UNITED STATES
DEPARTMENT OF THE INTERIOR
BUREAU OF LAND MANAGEMENTFORM APPROVED
OMB NO. 1004-0137
Expires: January 31, 2018**SUNDRY NOTICES AND REPORTS ON WELLS**
Do not use this form for proposals to drill or to re-enter an abandoned well. Use form 3160-3 (APD) for such proposals.5. Lease Serial No.
NMNM013885

Wellbore Plugging Plan

**Federal #1
Plugging & Final Abandonment**

CONDITIONS OF APPROVAL

Federal #1

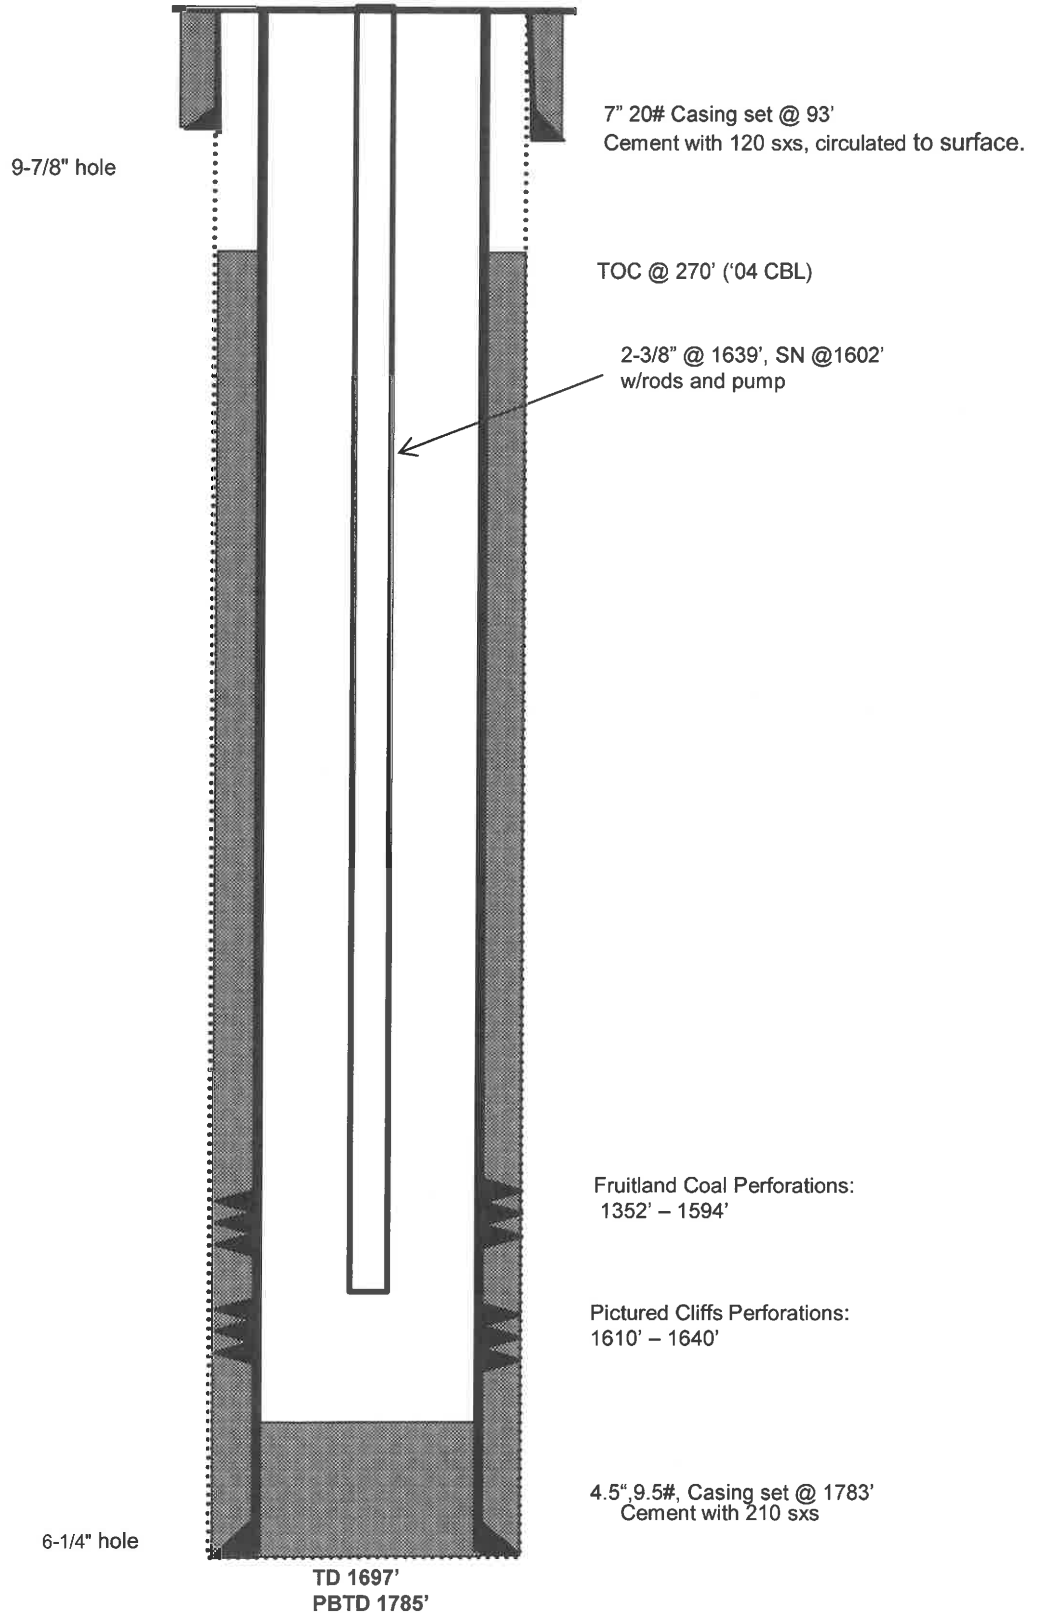
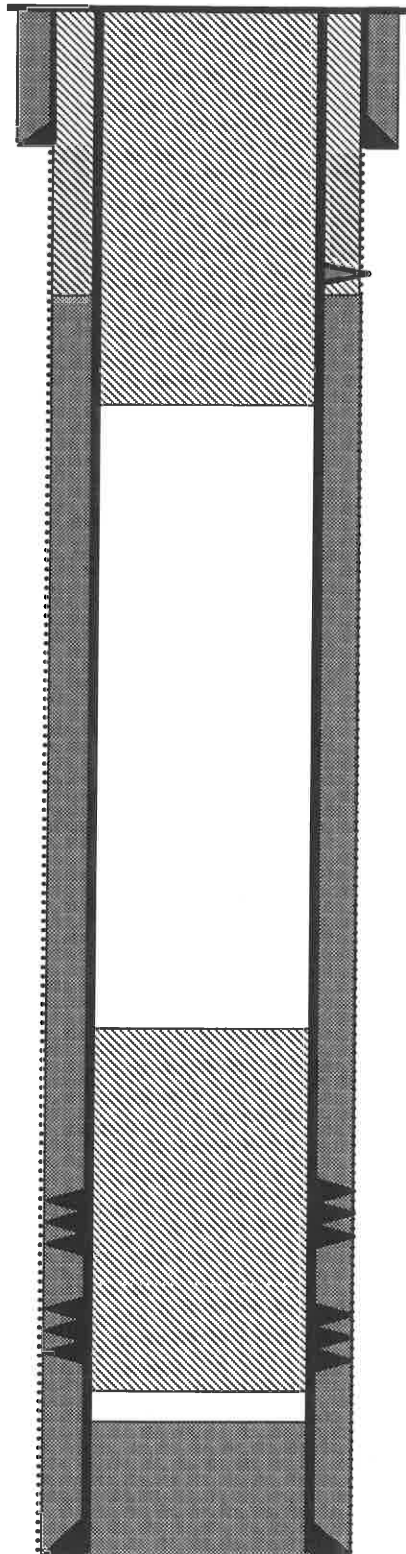
1. Plugging operations authorized are subject to the attached "General Requirements for Permanent Abandonment of Wells on Federal and Indian Lease."
2. Farmington Office is to be notified at least 24 hours before the plugging operations commence (505) 564-7750.
3. Submit the 2004 CBL to confirm cement coverage.
4. Submit electronic copy of the CBL for verification to the following addresses: jkillins@blm.gov , jhoffman@blm.gov and Brandon.Powell@state.nm.us . Based on CBL review inside/outside plugs and volumes may be adjusted accordingly. Please review the General Requirements document to ensure volumes meet required excess inside and outside casing.
 - a. BLM tops are based on the attached geologic report. Plugs will be adjusted based on cement coverage indicated by the CBL. Do not proceed with any plugging operations prior to reviewing CBL results with BLM and revising plug depths.

- BLM geologist's pick for the top of the Ojo Alamo formation varies from operator's. No change to proposed plug #2 is required.
- Log analysis of reference wells in the region indicate that Nacimiento and Ojo Alamo sands investigated likely contain fresh water ($\leq 5,000$ ppm TDS). These fresh water sands are adequately covered by the proposed surface plug (490' – Surface).
